▲ = Revised February, 1995

No. 93-13

Mercarb 2 Barrel Carburetor

New Float Setting

Adjusting Idle Mixture Screw

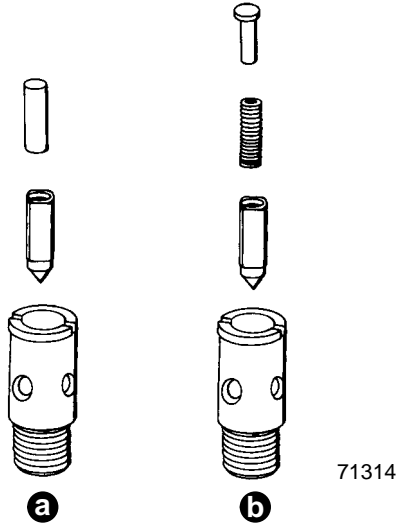
To adjust the idle mixture screw correctly, the throttle plates must be just about closed. To make sure that this is done, please do the following:

1. Disconnect throttle cable.
2. Reset idle speed (RPM) screw so engine idles at 550-600 RPM in neutral gear.
3. Adjust idle mixture screw.
4. Reset idle speed screw until engine idles at 650-700 RPM in forward gear.
5. Adjust and connect throttle cable.

- a - Solid Two Piece Needle
- b - Spring Loaded Needle

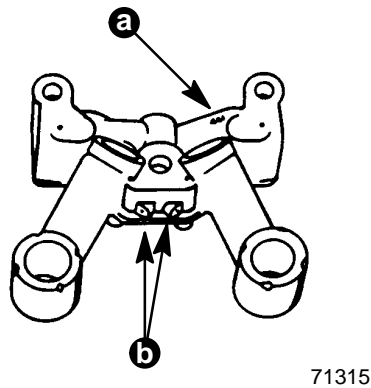
If all these items have been checked then you may want to check the type of needle and seat installed in the carburetor. Most MerCarbs use a solid two piece needle. The 3.0L carb P/N 1389-815396_ and 3.0LX carb P/N 1389-815397_ use a spring loaded needle.

If the carburetor has a solid two piece needle in it, install the spring loaded needle and seat kit. Reset float level to specification listed before.

Installing a spring loaded needle and seat kit on a 4 cylinder engine can cause a “lean out” condition in extremely hard turns. (GM 153, 181 CID: Right turn, Mercury 224 CID: Left turn). V6 and V8 engines should not be affected. Because of this potential “lean out” condition in extremely hard turns, you should make the boat owner aware of this condition before installing the spring loaded needle.

The spring loaded needle is the preferred one to use if you have a flooding problem at idle RPM.

Adjustable Accelerator Pump Lever

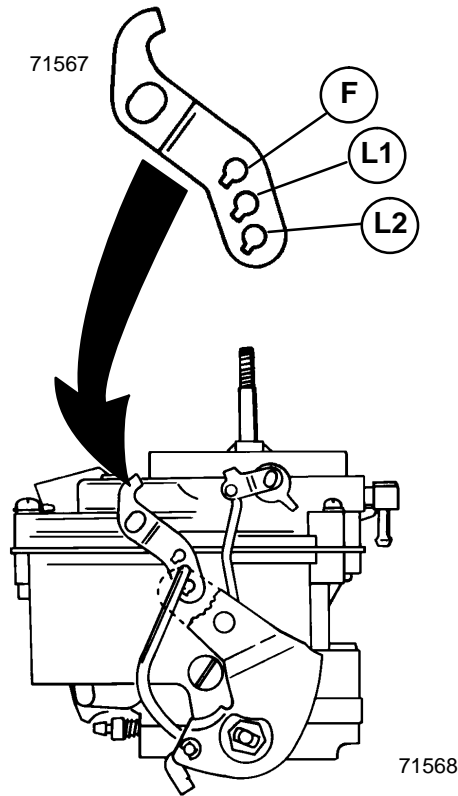
This new 3 holed lever will allow you to change the amount of fuel delivered to the engine by the accelerator pump. The hole closest to the lever's shaft, will give the same amount of fuel as the single hole lever did. The center hole gives approximately 0.5cc less fuel and the hole farthest away will give about 1.0cc less fuel.

- F** - Full Accelerator Pump Stroke
- L1** - 0.5cc Less Fuel Per Stroke
- L2** - 1.0cc Less Fuel Per Stroke

The technician should be able to correct most “bogging” problems with this 3 hole lever providing the “bogging” condition is caused by the carburetor. When installing the 3 hole lever, remove any metal ball that someone may have put in the accelerator pump well to limit pump travel. Also, make sure that the duration spring on the accelerator pump is stock and hasn't had several coils cut off. Make sure the venturi cluster is the correct one as outlined previously under “Identification”.

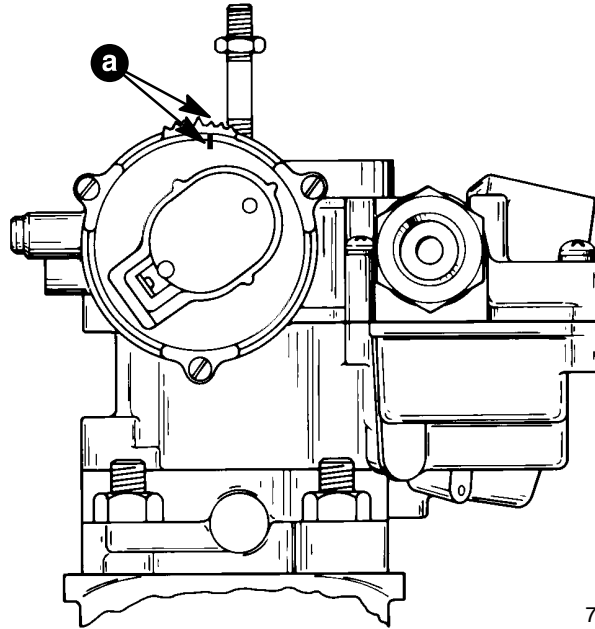
When installing this new lever in a carburetor that has a single hole lever, put the rod in the center hole. This will give 0.5cc less fuel to the engine on acceleration, than the single hole lever did. Test run boat in the water to see if bog has been corrected. Rod can be moved to other holes to richen or lean the pump stroke.

The 3 hole lever will be used on carburetors in production starting sometime in June, 1992. These carburetors will have the rod put in the center hole.
